# UNITED STATES PATENT AND TRADEMARK OFFICE

10/806,492

**Office Action Summary**

Title: "COLLAPSIBLE ENLOSURE WITH  
3-DIMENSIONAL TRIM ELEMENTS"

REPLACEMENT SHEET

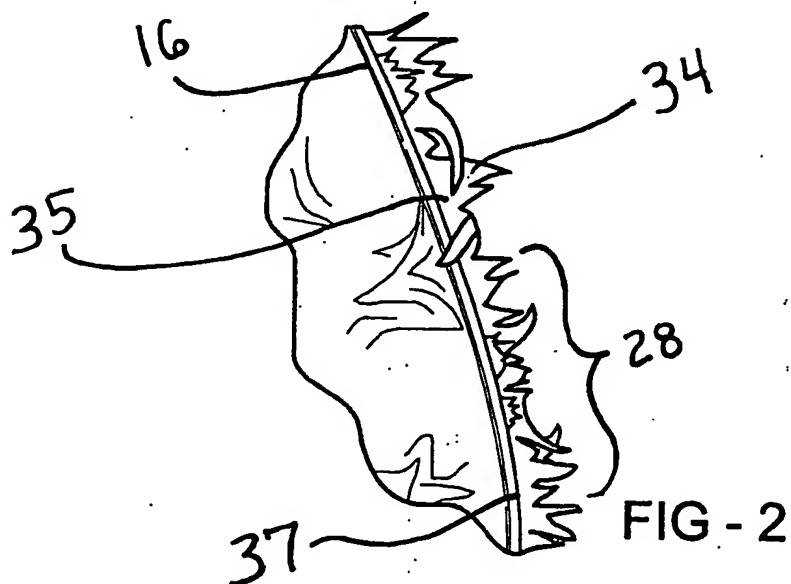
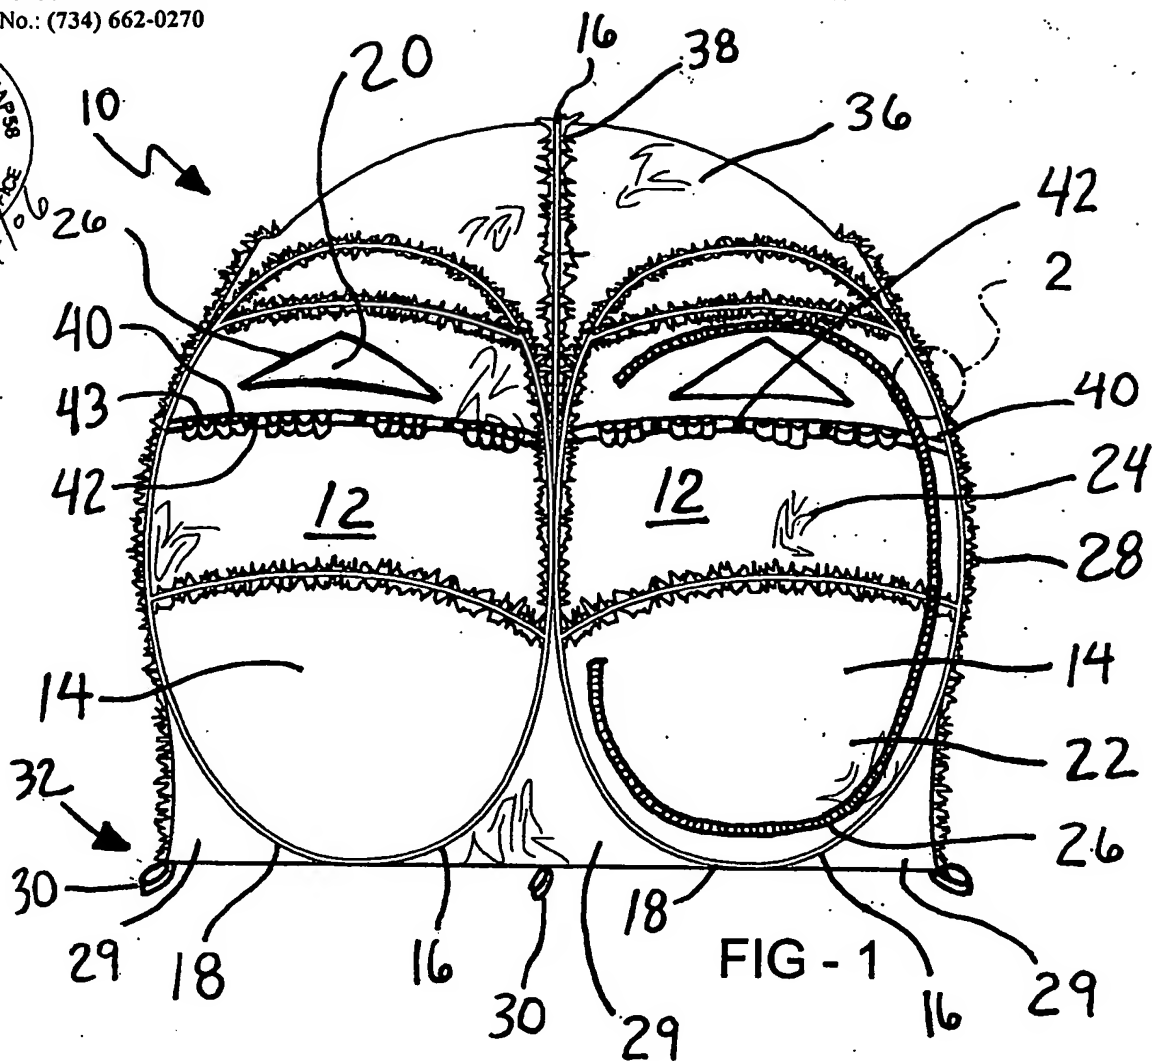
1. The drawings are objected to under 37 CFR 1.83(a). The drawings must show every feature of the invention specified in the claims. Therefore, the features such as “a hinge section attached to the sleeve to allow leaf elements to move in relative to the sleeve” (claims 13 and 19) and “the cutout elements are shaped as circles” (claims 15, and 22) must be shown or the feature(s) canceled from the claim(s). However, in the drawings, the referent character “37”, does no appear to be a hinge section as defined in the specification. No new matter should be entered.

Corrected drawing sheets in compliance with 37 CFR 1.121(d) are required in reply to the Office action to avoid abandonment of the application. Any amended replacement drawing sheet should include all of the figures appearing on the immediate prior version of the sheet, even if only one figure is being amended. The figure or figure number of an amended drawing should not be labeled as “amended.” If a drawing figure is to be canceled, the appropriate figure must be removed from the replacement sheet, and where necessary, the remaining figures must be renumbered and appropriate changes made to the brief description of the several views of the drawings for consistency. Additional replacement sheets may be necessary to show the
